VOLLMER ROAD (BARBARICK) -INTERIM CONDITION

GRADING AND EROSION CONTROL PLANS

JULY 2023

VOLLMER ROAD (BARBARICK) -INTERIM CONDITION
 COVER SHEET

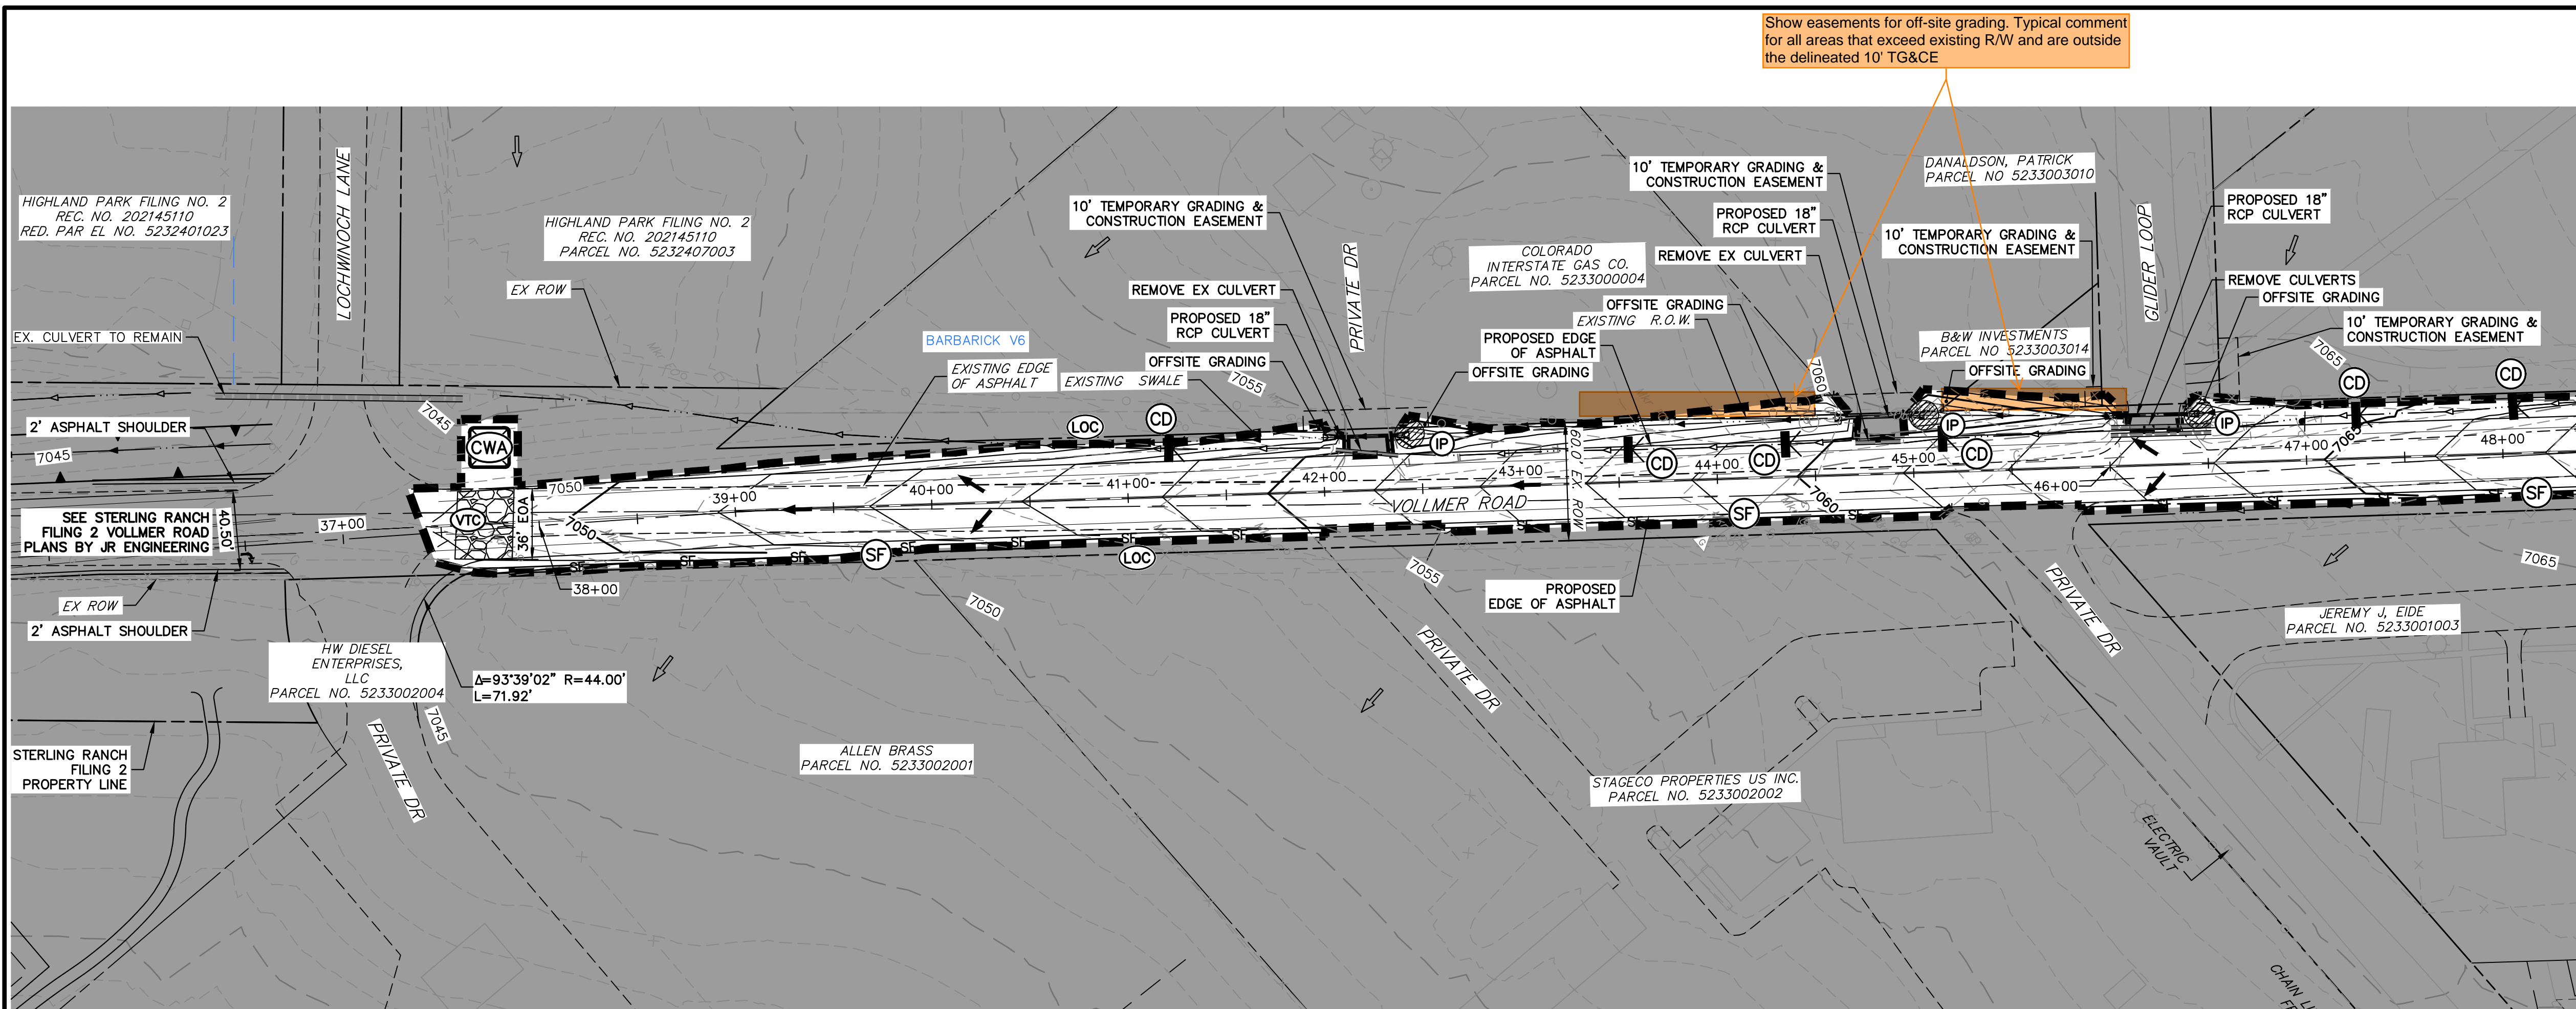
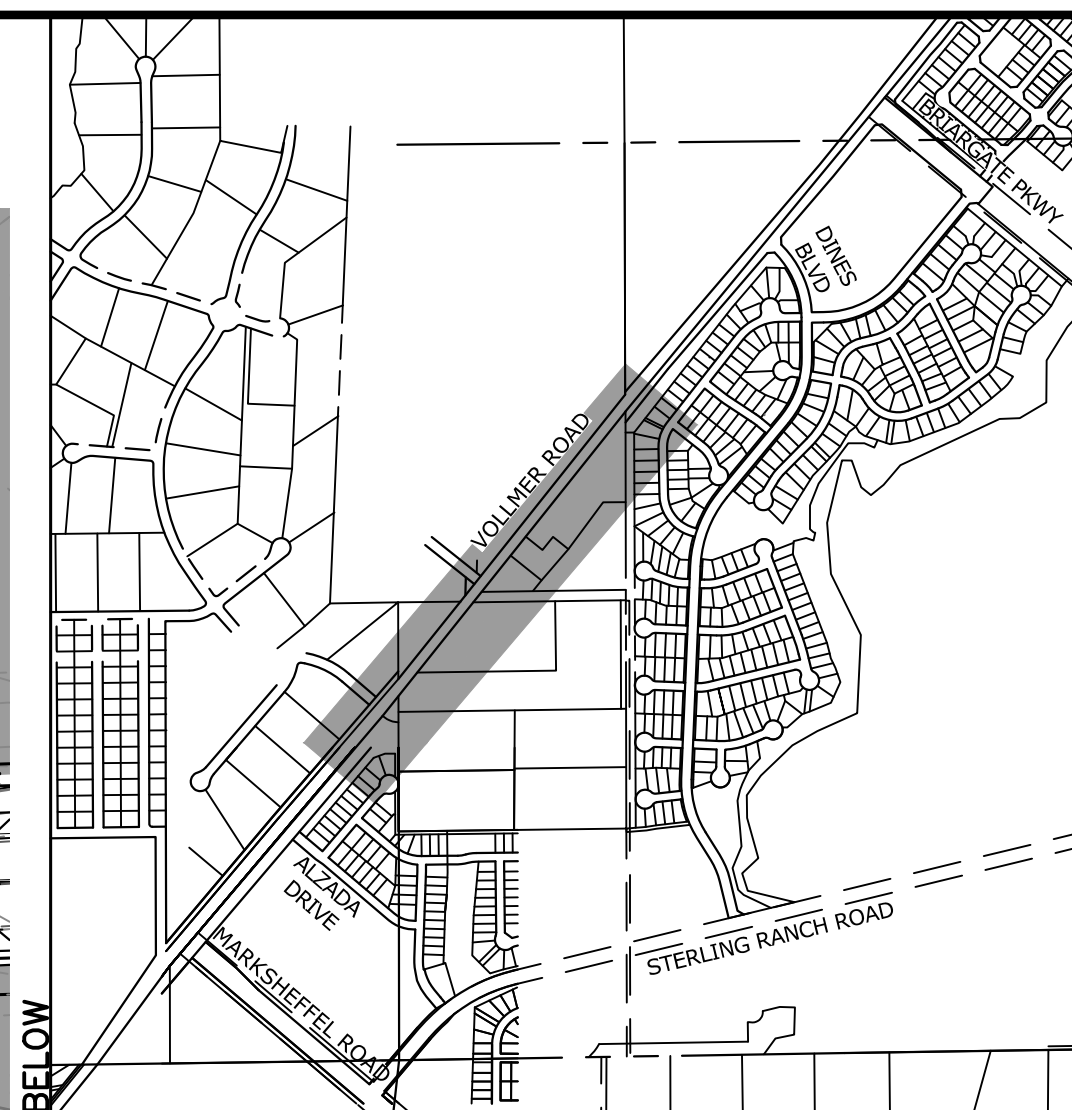
has obtained? Verify. The plans show easements.

Show easements for off-site grading. Typical comment for all areas that exceed existing R/W and are outside the delineated 10' TG&CE

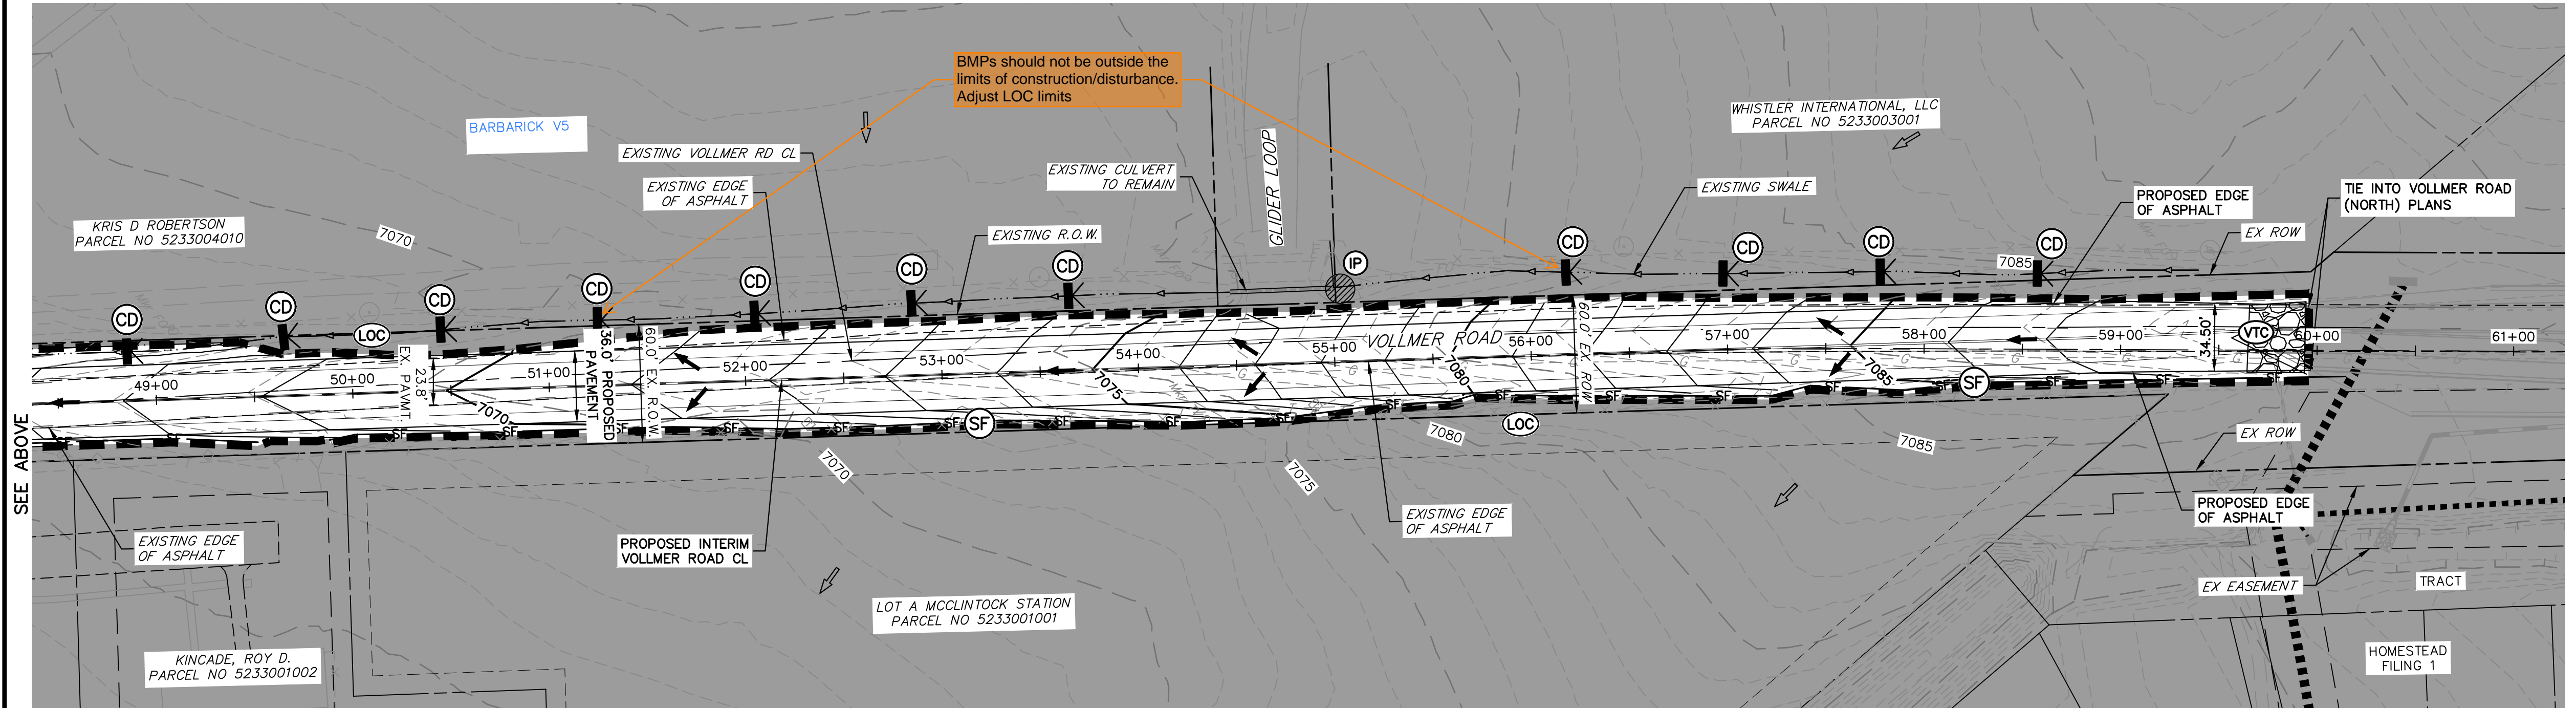
GEC Checklist Item g: Show all existing utilities. If no utilities are present add a note to that effect.
